Re: Environmental Noise Survey
Elan Keller
Keller, Texas

TECHNICAL MEMORANDUM

From: Leslie Sagar
Sent: Monday, November 16, 2020 4:02 PM
To: Jerald Ducay
Cc: Gary Ponder
Subject: Re: CenterStage - Realty Capital

Re: Response to Email from Leslie Sagar re: **FRA Noise Model**
Greystar - Elan Keller Project
Keller, Texas

Figure 1: Measurement Locations

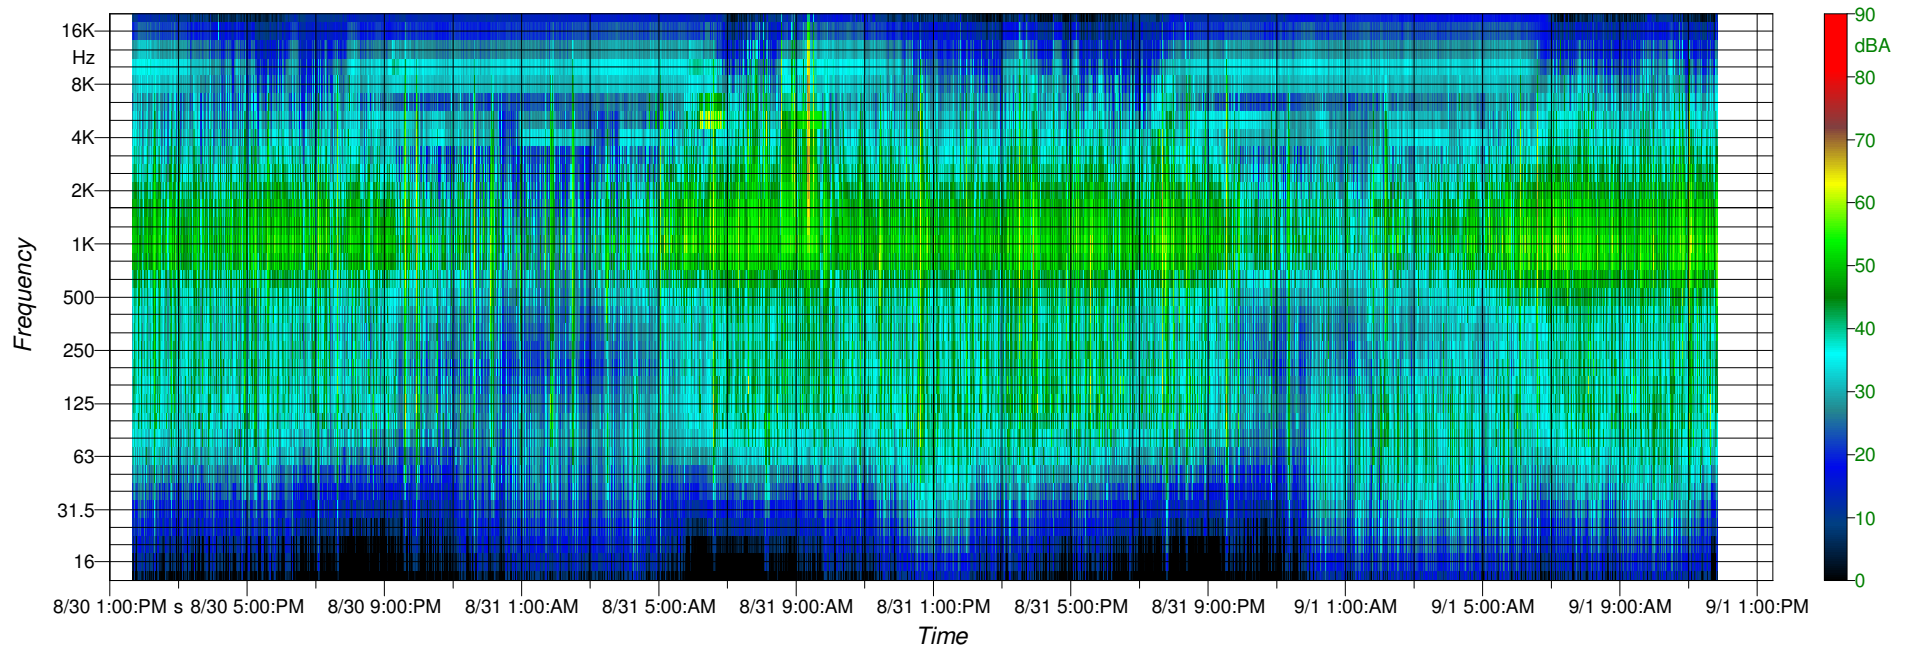
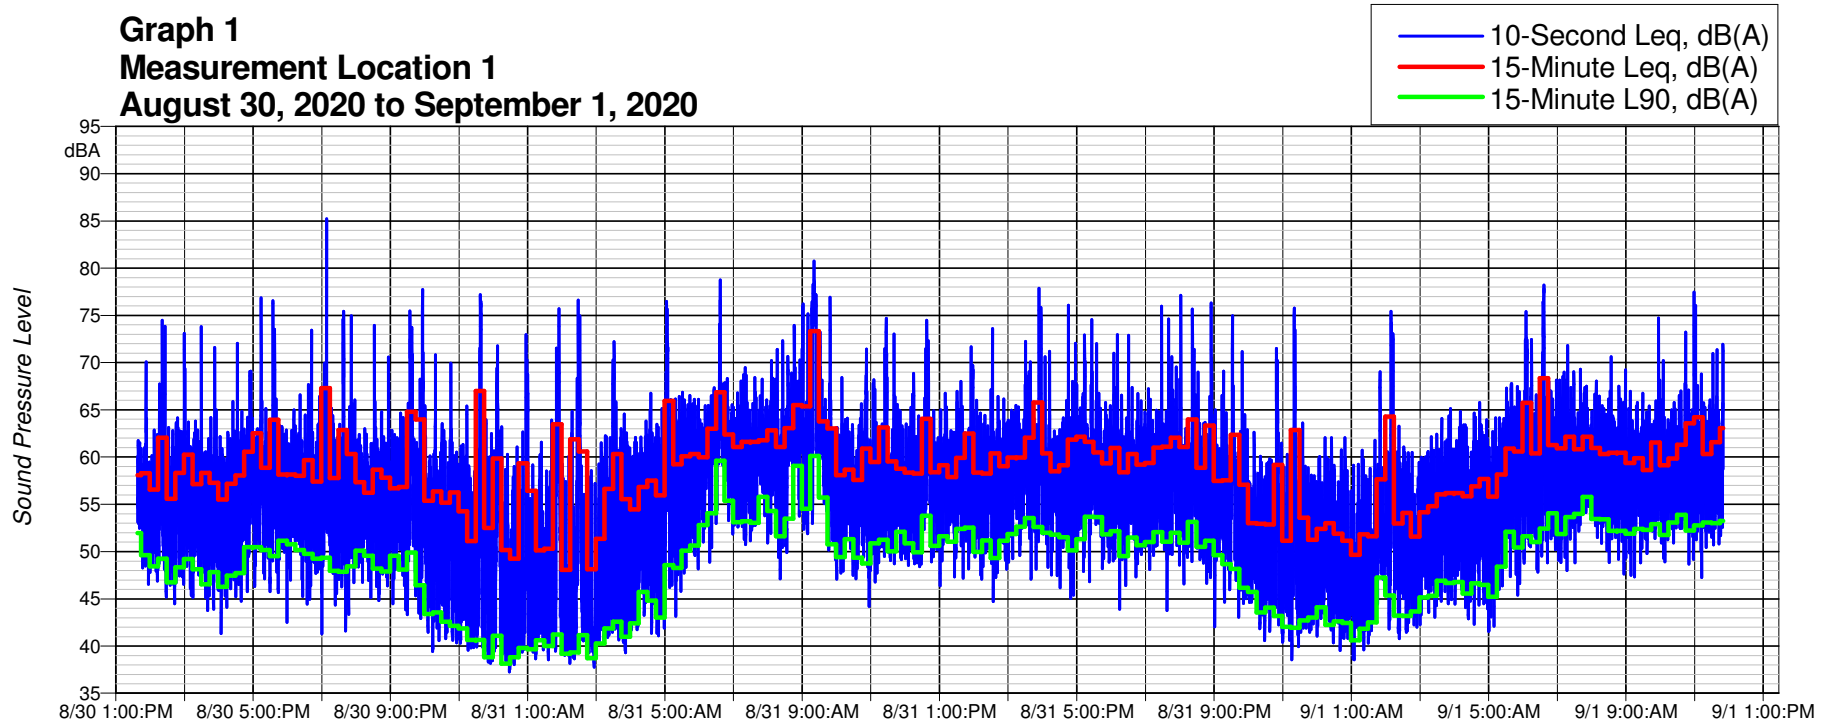
3. At a minimum, the FRA Horn Noise MS Excel spreadsheet model needs to be used using the information in Comment 2 above to assess the noise impacts at the two nearby at-grade crossings of Hwy 377 at Mt. Gilead Rd., and Hwy 377 and Keller-Haslet Rd. The output of this model provides the 65DNL contour distance from the rail line, and this 65DNL contour needs to be overlaid onto a project site plan in relation to the proposed buildings and other project features.

5. Mitigation measures can be accomplished for noise levels between the 65DNL and 75DNL contours; however, it is important to know where these contours are in relation to the project site. The site plan may need to be modified so that incompatible land uses do not occur within the 65 DNL contour. Noise level reduction measures to reduce interior sound levels to a maximum 45db are appropriate, but the measures proposed in the Technical Memorandum do not mitigate the exterior noise levels of the proposed sidewalk cafes, outdoor music venue and other outdoor public areas that were presented by the applicant as part of the development.

The Federal Railroad Administration (FRA) noise model is a predictive model that provides a DNL noise contour which is used to assess land use compatibility. SLR's analysis used 48-hours of site-specific empirical data to characterize the environmental sound levels at the site, including rail noise. As such, it is unnecessary to use the FRA model to theoretically predict the rail noise levels at these locations since we have measurements of the actual levels. Predictive modeling would be appropriate if there was reason to believe that rail traffic may increase in the future, but that is not the case with this project. And, although freight traffic may vary somewhat from day to day, the data we collected were very consistent with the FRA data for these crossings which indicate an average of 20 to 24 trains per 24 hour period. Therefore, using a predictive model such as the FRA model will not improve on the quality of data that we have already obtained and incorporated into our analysis and recommended noise mitigation treatments for the project.
